Access Compliance Report

Intersection ID: 14763	Main Street: HERMITAGE_RD	Cross Street: QUEENS_RD	Location: SW
ADA ID: ED5DCC77AEA2	Ramp Type: Directional1	Initial Pass/Fail: Pass	Overall Compliance: No
Severity Score: 2.75			
Codes/Mitigation Info/Possible Solution		Field Measurements/Component Compliance

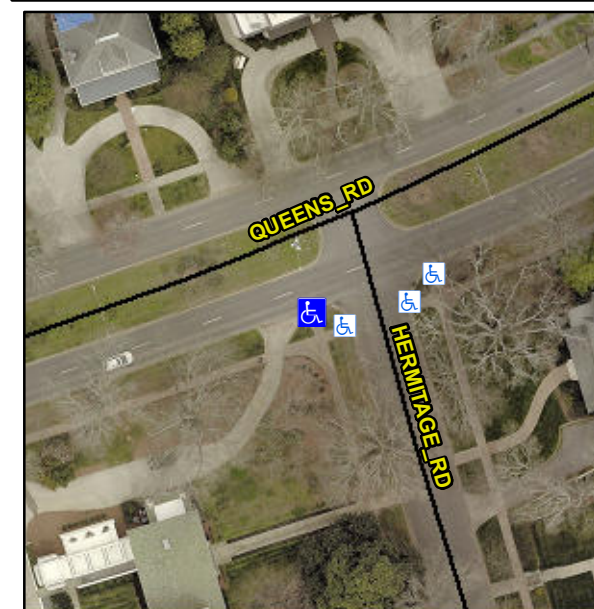
**R304.5.3, R304.2.1, R304.2.2-Perp,
R304.3.2-Para, R305.1.4, R305.2**

Compliance	Description	Data	Compliance	Description	Data
N/A	Ramp Length (in)	117.0	Yes	Grade Break?	Yes
Yes	Ramp Width (in)	48.0	Yes	Grade Break Slope (%)	4.8
Yes	Ramp Slope (%)	7.7	No	Grade Break XSlope (%)	2.3
No	Ramp XSlope (%)	2.6			
N/A	Flare Type LT	N/A	N/A	Flare Type RT	N/A
Yes	Flare Slope LT (%)	2.5	Yes	Flare Slope RT (%)	0.4
N/A	Flare Traversable LT?	Yes	N/A	Flare Traversable RT?	Yes
No	Landing Length (in)	47.0	Yes	DWS Provided?	Yes
Yes	Landing Width (in)	65.0	Yes	DWS Contrast?	Yes
No	Landing Slope (%)	4.8	Yes	DWS Length (in)	25.5
Yes	Landing X Slope (%)	0.5	No	DWS Full Width?	No
N/A	Landing Curb? (Y/N)	N/A	Yes	DWS Offset LT (in)	15.0
N/A	Shared Landing?	No	No	DWS Offset RT (in)	5.0
Yes	Gutter Ponding?	No	Yes	Gutter Slope (%)	2.9
Yes	Gutter Lip Ht (in)	0.0	No	Gutter X Slope (%)	2.2
N/A	Painted X Walk1?	No		Road Slope (%)	2.0
	X Walk 1 Direction	To NW		Road X Slope (%)	0.6
	X Walk 1 Width (in)	N/A		Clear Space?	Yes

**Remove & Replace Entire Ramp.
Remove & Replace Gutter.**
